PROJECT NO. 17226

LANDSCAPE PLAN

L1.0

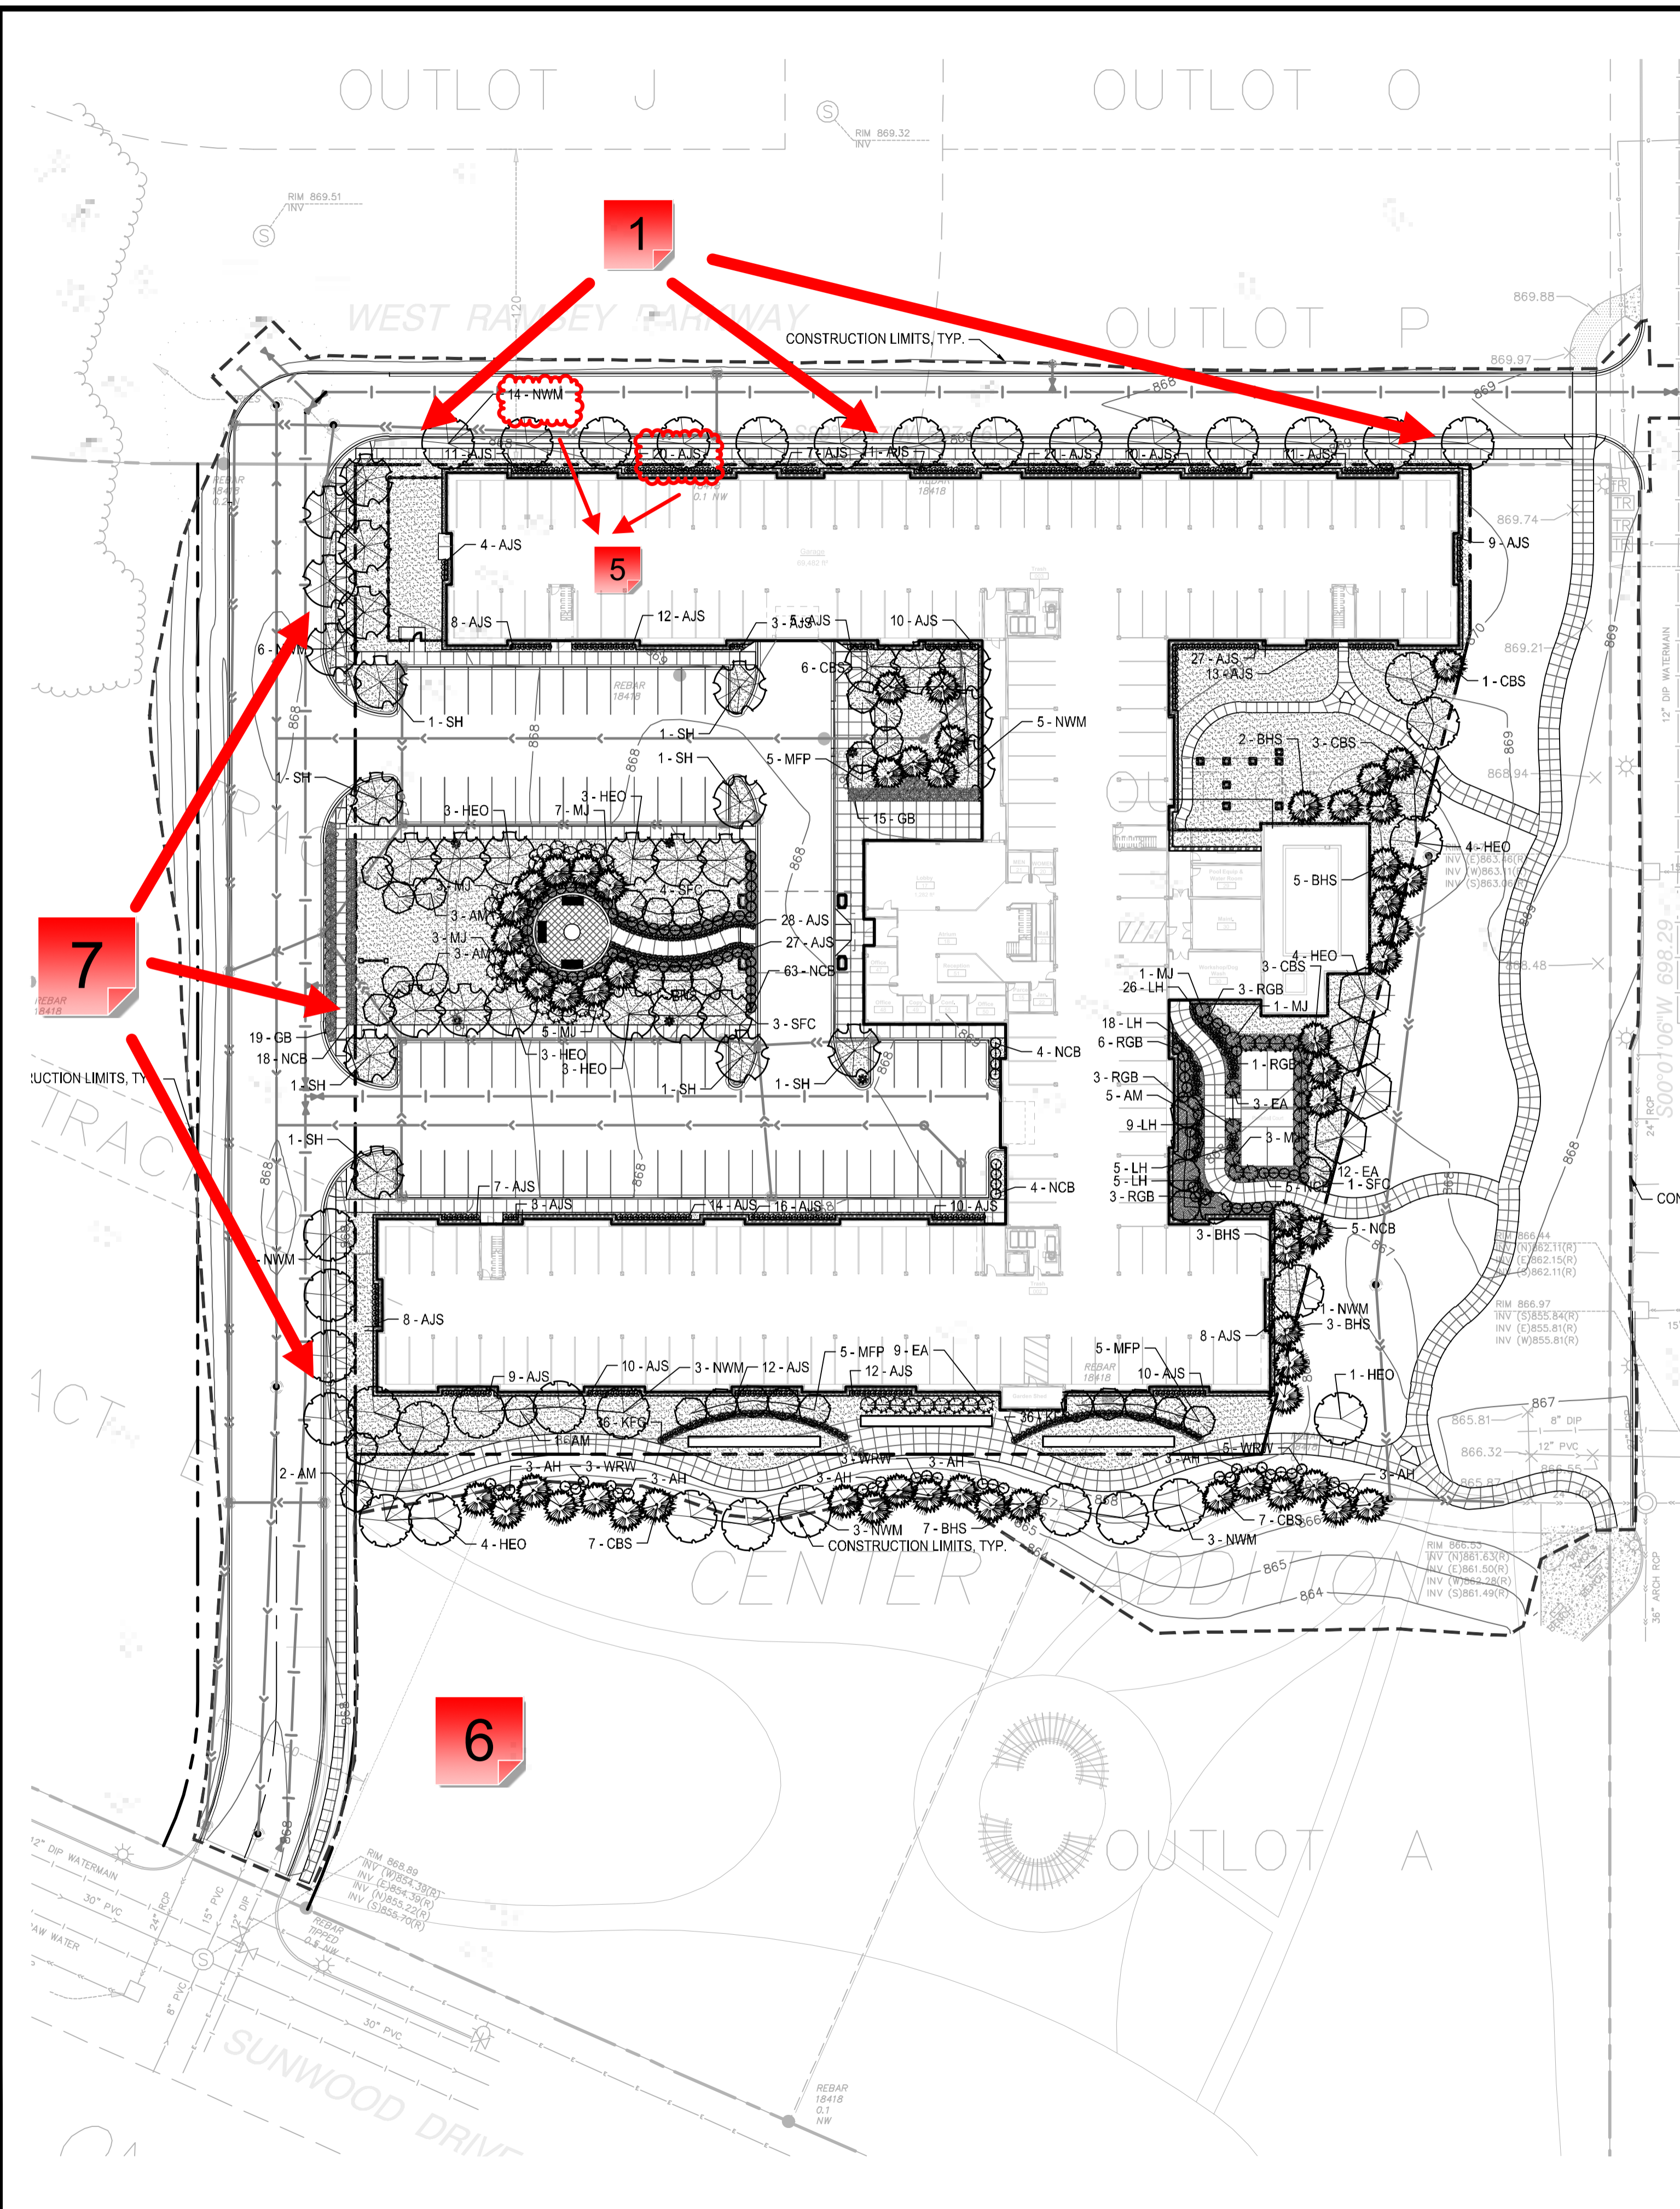
4 inches of topsoil, meeting the City's specification, and sod required in boulevard.

Boulevard width shall be six (6) feet as outlined in the COR1 Development Standards found here:

The City requires a Landscape Maintenance Surety (addressed in the Development Agreement) to ensure survival of all plantings for a two (2) year period following acceptance of plantings per approved plan by City.

Irrigation system must include a rain sensor AND at least one water efficient technology such as: soil moisture sensor(s), smart controller, ET sensor, etc.

It appears that the scale should be 1" = 40'-0". Please correct.

Labeling of species is obscured. Readjust text so that each species is clearly identifiable or add the species symbol to the planting schedule.

Sidewalk width must be six (6) feet along Ramsey Parkway and ten (10) feet along the north/south street. Ramsey Parkway is classified as a Parkway Street and the north/south street is classified as a Downtown Street. Please refer to the COR1 Development Standards here:

This street is classified as a Downtown Street per the Design Framework and requires a ten (10) foot wide sidewalk. See completed portion of Center Street for example. Descriptions of street types, the street hierarchy map, and a photo illustration of a 'Downtown' street sidewalk can be found here:

This species is only hardy to zone 5. Replace with a more location appropriate species. If oak is preferred, would suggest Bicolor Oak (*Quercus bicolor*).

Amur Maple is a prohibited species and cannot be included on the planting schedule. We are not familiar with Mountain Frost Pear. While it appears to be hardy to zone 3, this may be difficult to obtain commercially and an alternative species should maybe be considered.

Both of these shrub species are prohibited species and must be replaced with alternates.

Add note that specifies that all disturbed areas not otherwise improved with impervious surfaces (building, parking lot, sidewalk, etc.) shall receive four (4) inches of topsoil, meeting the City's specification, before landscaping is installed.

Load tickets are required as is a topsoil inspection before landscaping is installed.

Contractor shall coordinate a Pre-Planting meeting with City Staff before installing any trees in the public right of way. Contractor shall provide at least 48 hours notice to schedule this meeting.

Sidewalk panels shall have alternating brush strokes per City specification.

Once the City approved the Landscape Plan, there shall be no changes to the species in the Plant Schedule without first receiving approval from the City.
